CITY OF ALBUQUERQUE

RE: **Route 66 Plaza**
8521 Central NE
Grading Plan Stamp Date: 1/14/19
Hydrology File: K19D043

Based on the submittal received on 1/16/19, the grading plan cannot be approved for Building Permit until the following are corrected:

DRAINAGE PLAN

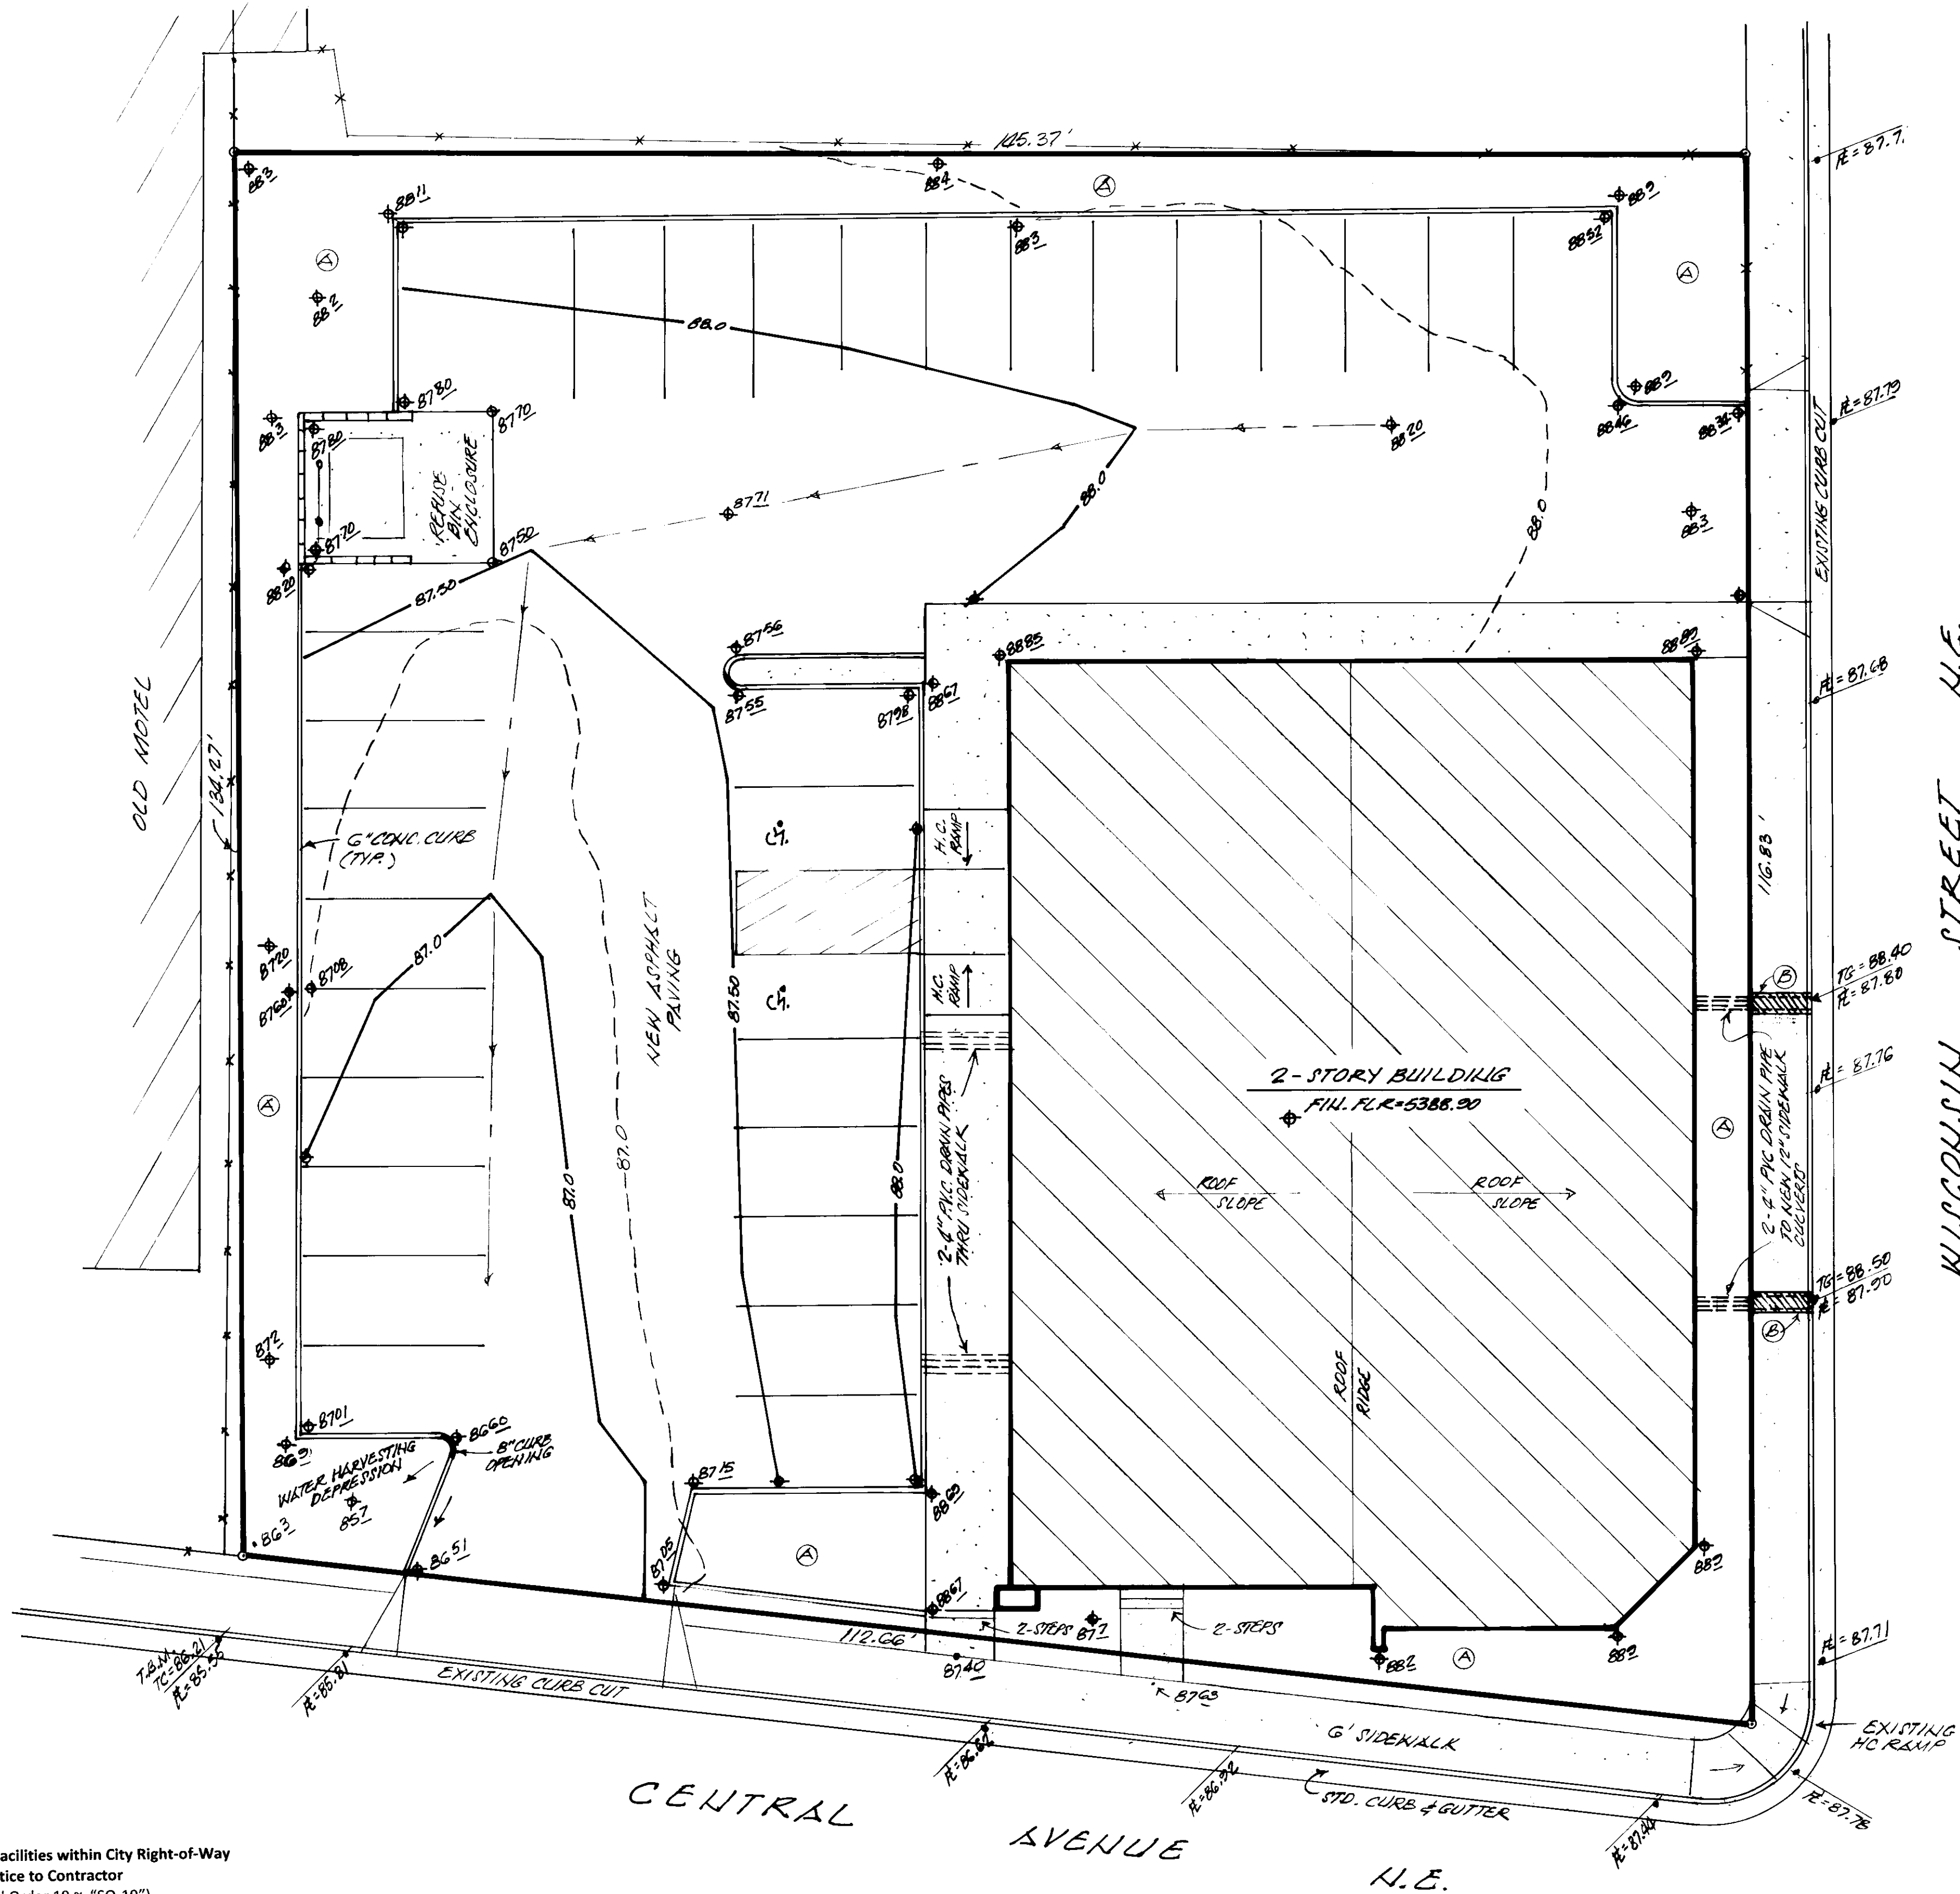
1. Include project benchmark and datum.
2. The Engineer's Seal and the FIRM Map are illegible. Also, it isn't necessary to include the Building Permit APPROVAL Stamp.
3. Payment of the Fee in Lieu (Amount = $306\text{CF} \times \$8/\text{CF} = \2448) for the required stormwater quality volume must be made. Include a copy of the paid receipt when resubmitting.
4. Because of the minor nature of these corrections, the resubmittal fee is waived. Please include a copy of this letter when resubmitting to avoid to resubmittal fee.
